Subject: Hydrant condition - BN/57/19/RES Land East of Fontwell Avenue Fontwell Avenue Fontwell BN18 0SB

HYDRANT CONDITION CONSULTATION WITH PLANNING AUTHORITY

Planning Ref: BN/57/19/RES

Description: Approval of reserved matters for 3785sqm of light industrial
floorspace (Class B1 (b)/(c)) following the grant of
WA/22/15/OUT.

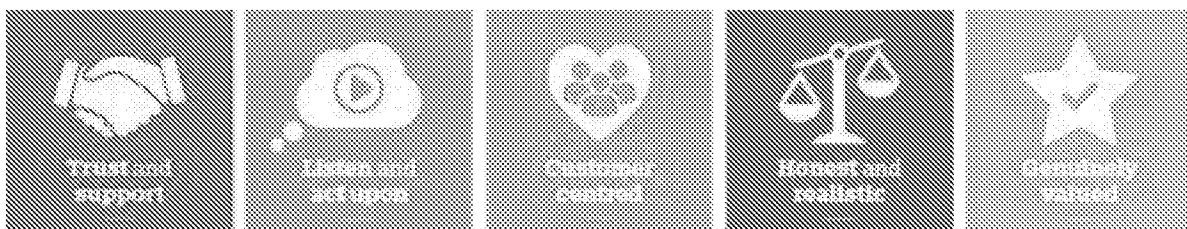
Please find attached a planning condition for application no. BN/57/19/RES for the requirement of an additional fire hydrant. Currently the nearest Hydrant to these proposed properties is 290 metres away. The supply of water for firefighting for a commercial premises should be within 90 metres.

- 1) Prior to the commencement of the development details showing the proposed location of [1] one fire hydrant or stored water supply (in accordance with the West Sussex Fire and Rescue Guidance Notes) shall be submitted to and approved in writing by the Local Planning Authority in consultation with West Sussex County Council's Fire and Rescue Service. These approvals shall not be unreasonably withheld or delayed.
- 2) Prior to the first occupation of any dwelling/unit forming part of the proposed development that they will at their own expense install the fire hydrant (or in a phased programme if a large development) in the approved location to BS 750 standards or stored water supply and arrange for their connection to a water supply which is appropriate in terms of both pressure and volume for the purposes of firefighting.
